**1 Products affected**

**2 Type of change**

Change of the marking on the socket of the fuseholder.

OGD/OGD-SMD					0118.2160	
creation date	created by	release date	released by	notification no.	revision	page
2013-01-22	arnetja	2013-02-18	arnetja	24330	-	1 of 2

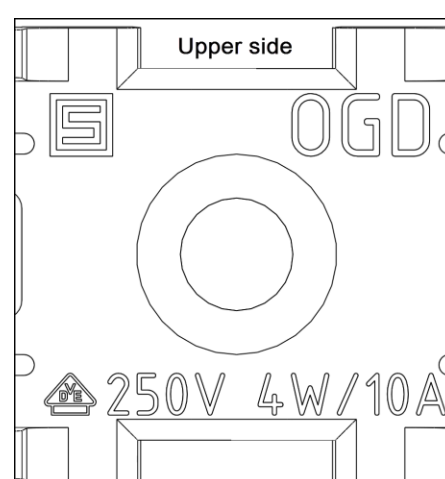
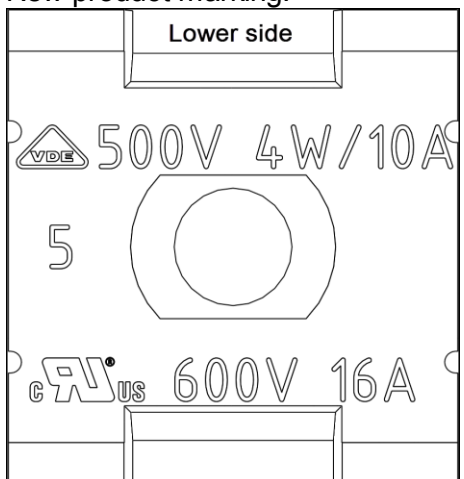
Old product marking:

New product marking:

Marking of all ratings and approvals added on the fuseholder.
